Appendix 5: Pre-hearing meeting notes

IN THE MATTER OF: A private plan change request by Oakura Farm Park Ltd to change the Operative District Plan to enable future development at land situated at 156 Upper Wairau Road and 1215-1277 South Road, State Highway 45, Oakura.

**PRE-HEARING REPORT PURSUANT TO SCHEDULE 1 CLAUSE 8AA (5) OF
THE RESOURCE MANAGEMENT ACT 1991**

DRAWING
 C-09

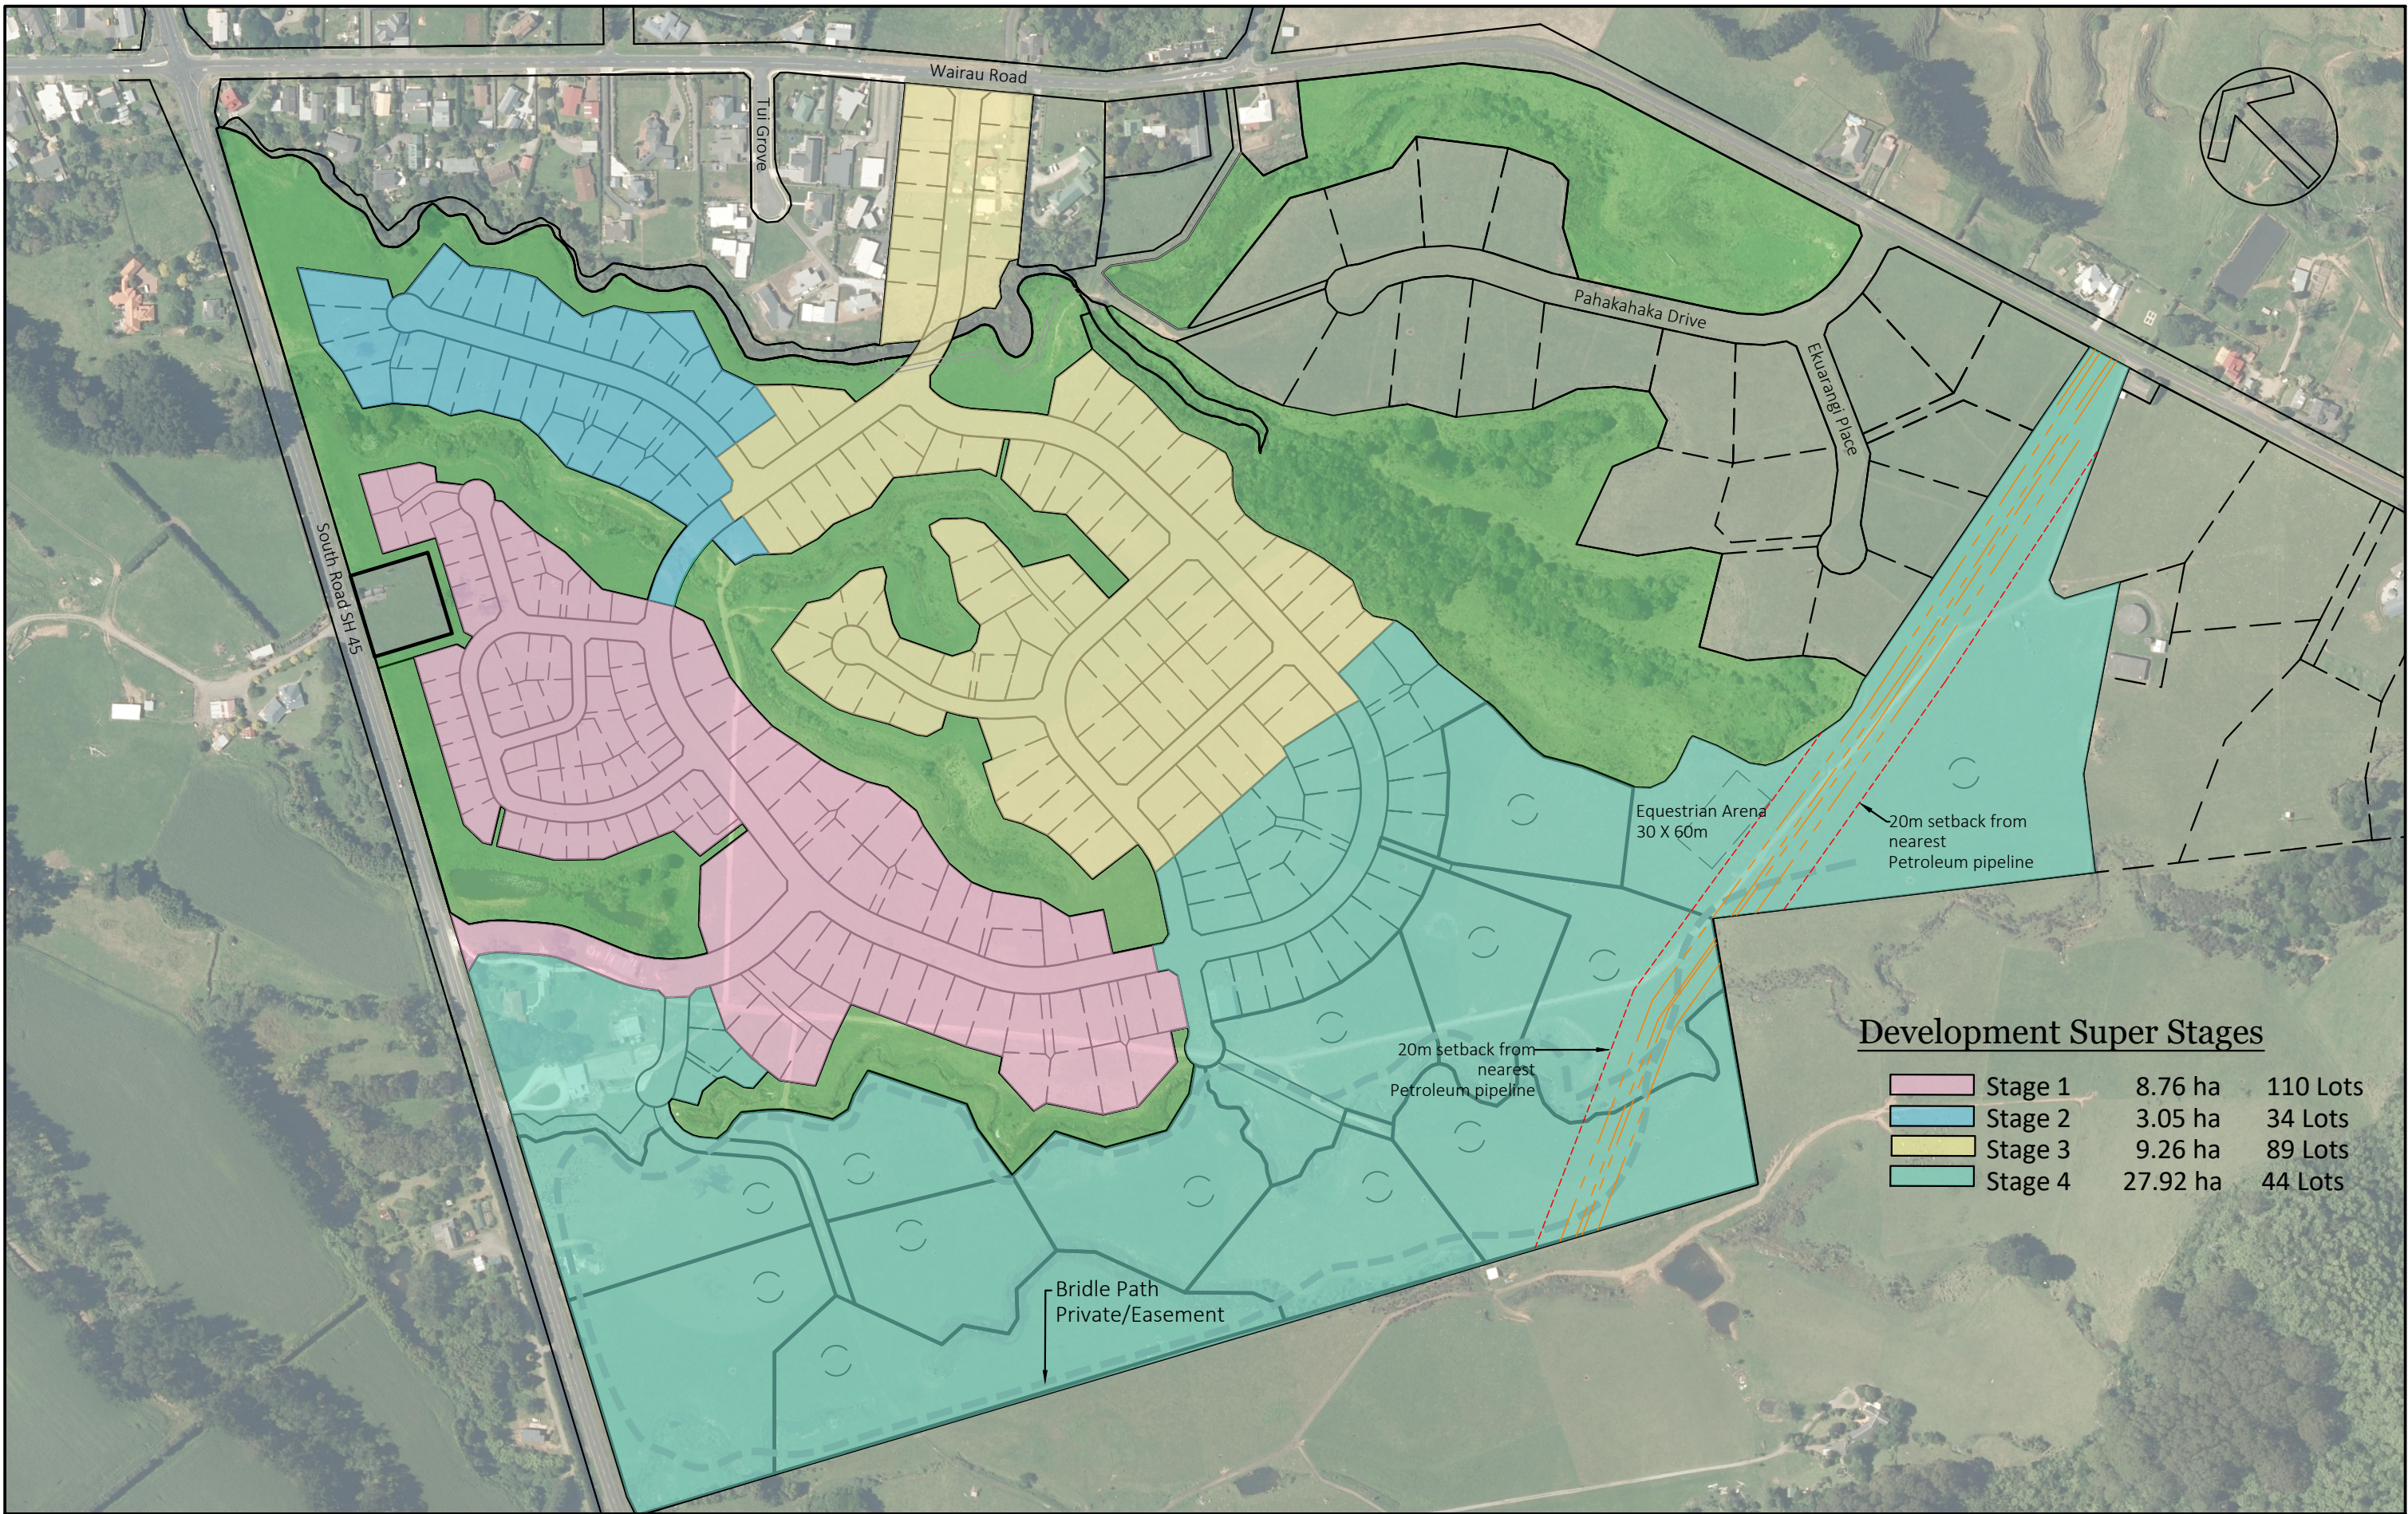
27. The National Road Carriers Association identified that they would probably support this concept. NZTA queried whether the roundabout would be included and noted that traffic volumes would need to be considered. The applicant acknowledged that they are still working on the planning for this alternative. NZTA then queried as to whether the alternative would solve the safety issues.

31. The applicant acknowledged that the alternative would meet submitters concerns. However, NZTA wished to reserve its position pending a more detailed consideration by their traffic engineer. NPDC queried whether the FUD on the Western side would have access to SH 45. The applicant suggested the work that had been done for the Western FUD indicated 450 potential lots and showed access to SH 45 immediately opposite to the applicant's alternative proposed access point. The applicant noted that when the FUD West is triggered and Plan Change 48, then this would trigger the roundabout. The applicant noted that the southern extent FUD West would define the urban line, to which the National Road Carriers Association noted happens naturally.

48. The following matters were agreed on during the meeting:
 - Applicant to confirm whether it is proposing a new/alternative staging plan, including whether plan provisions are proposed to link development of stages with provision of infrastructure (i.e. new roundabout and underpass on SH45)
